**DOCKET**  
**08-AFC-13**

RE: Calico Solar (Formerly Solar One) Project  
Applicant's Submittal of the Revised Calico Solar Project Layout Figure

**CALICO SOLAR PROJECT LAYOUT**

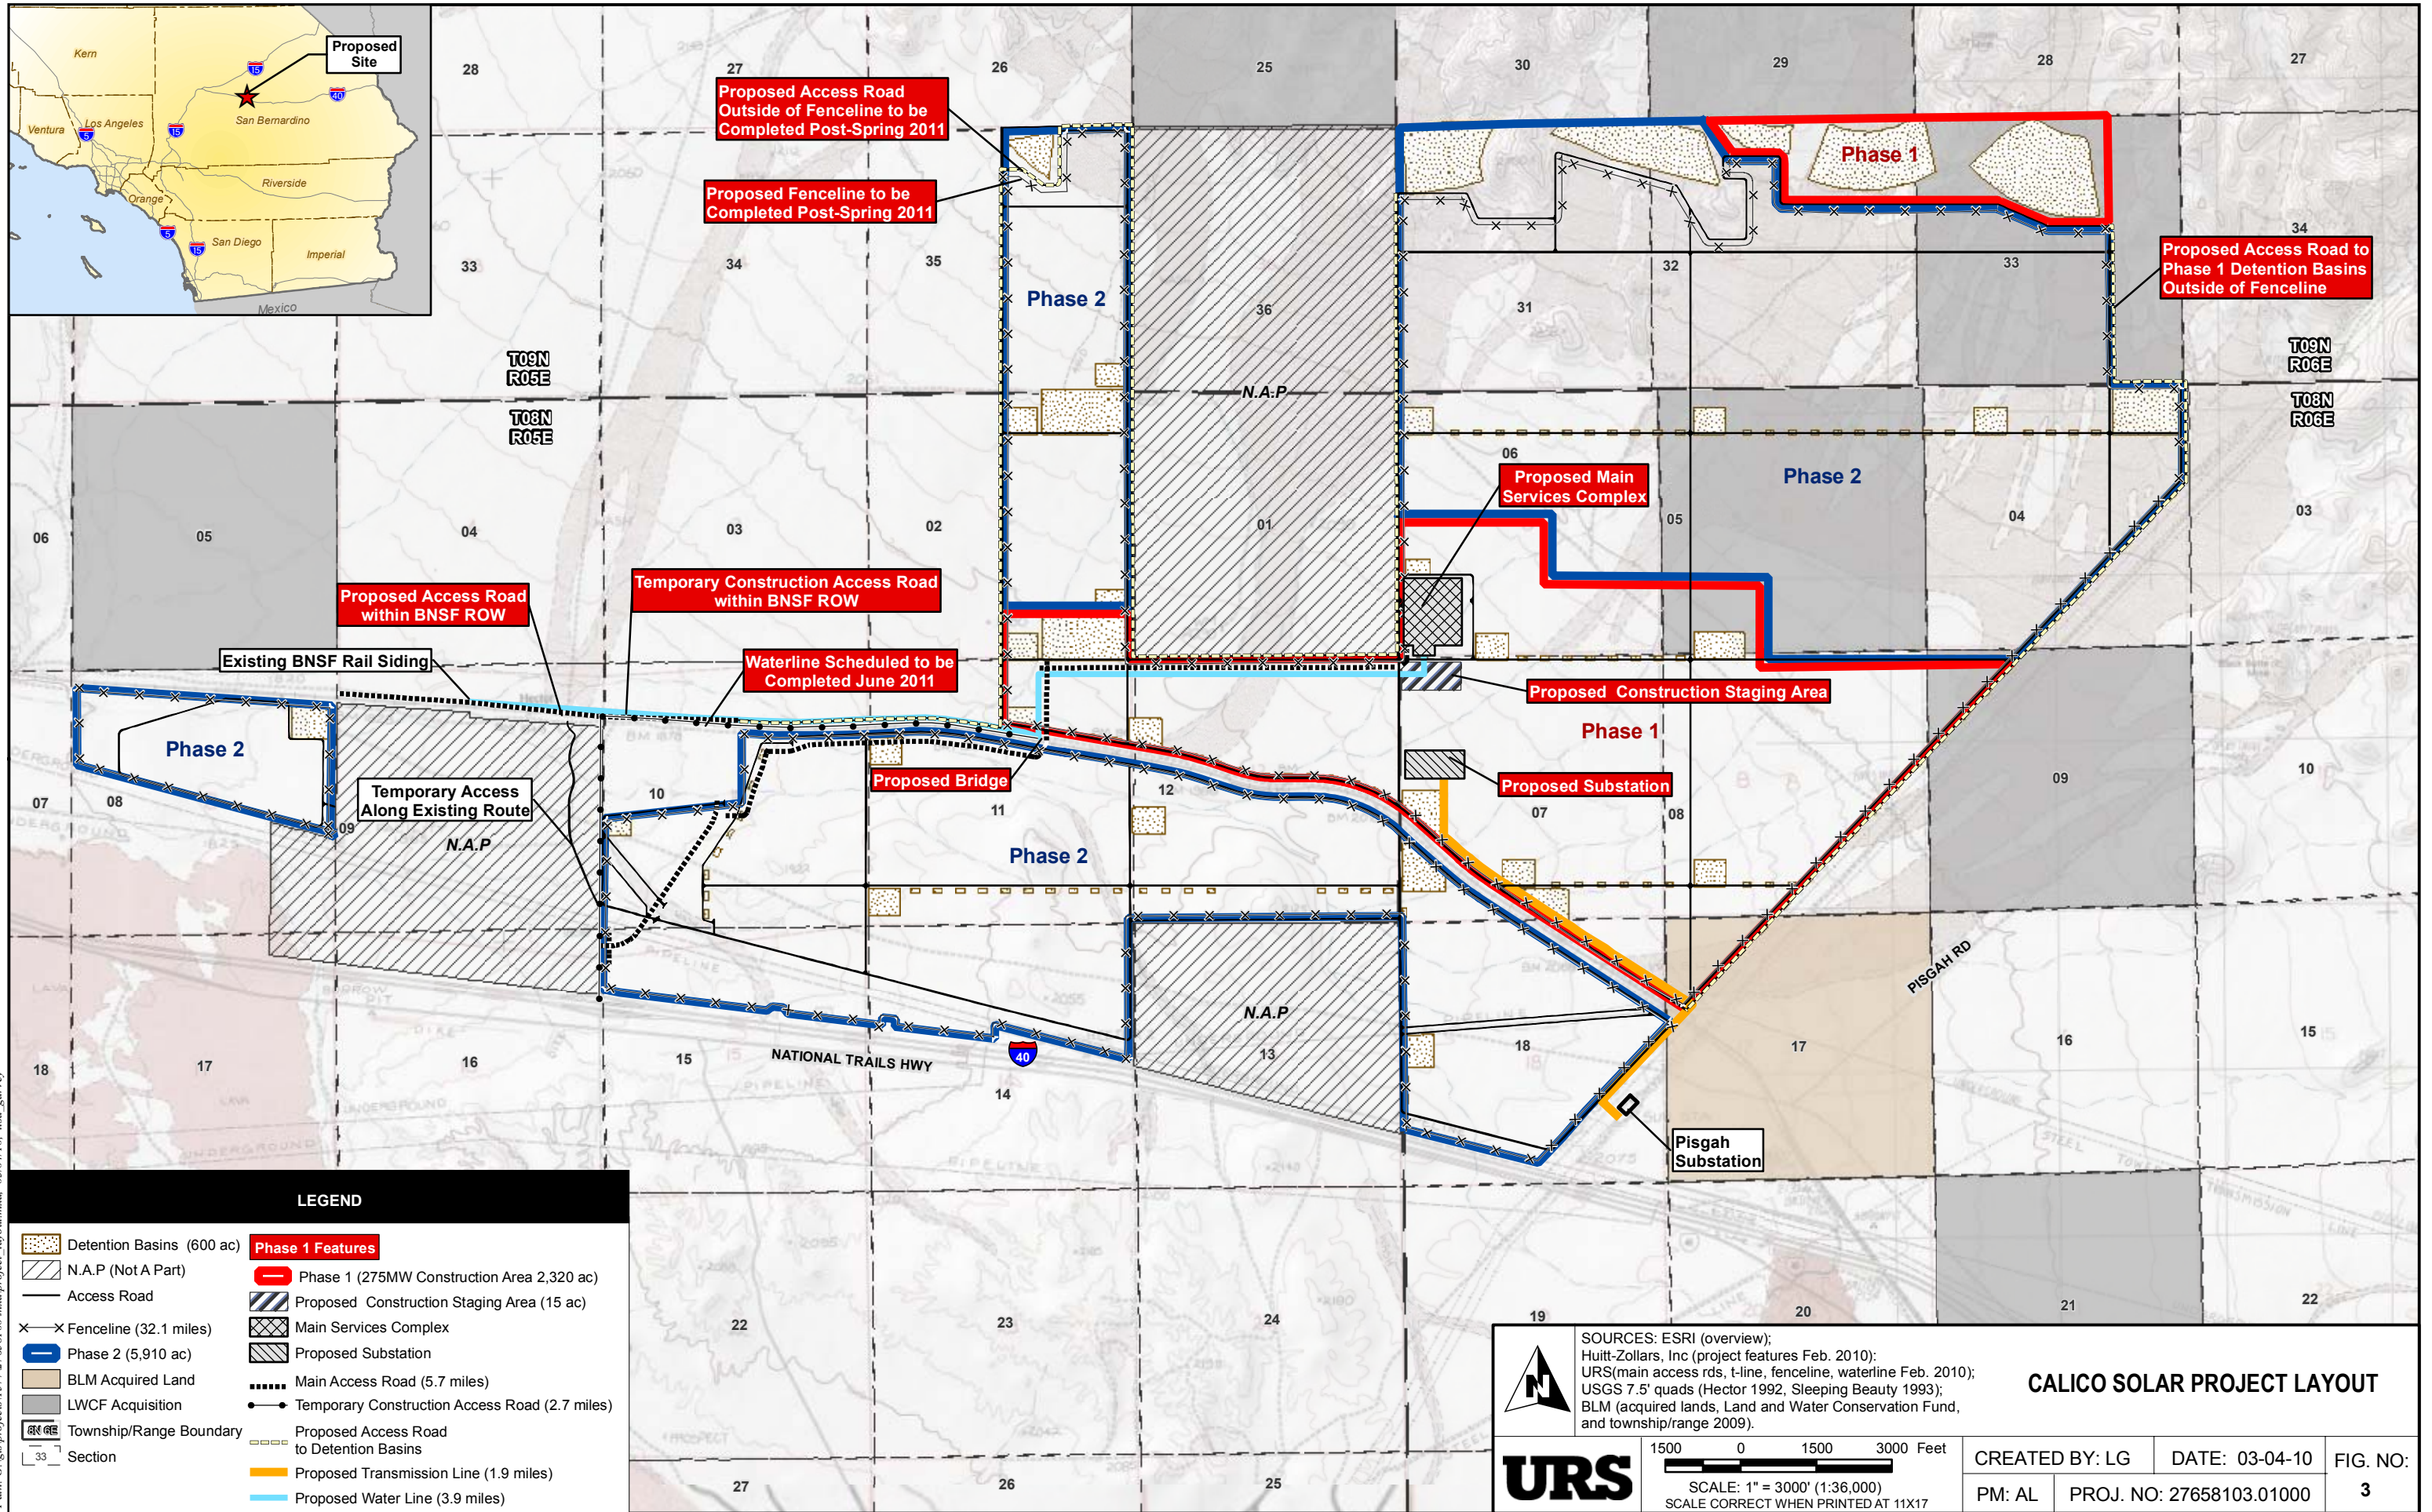
Tessera Solar hereby submits the Applicant's Revised Calico Solar Project Layout Figure. The figure incorporates revisions to the areas included as Phases 1 and 2 of the Project, and it identifies the Project features associated with each phase. I certify under penalty of perjury that the foregoing is true, correct, and complete to the best of my knowledge.
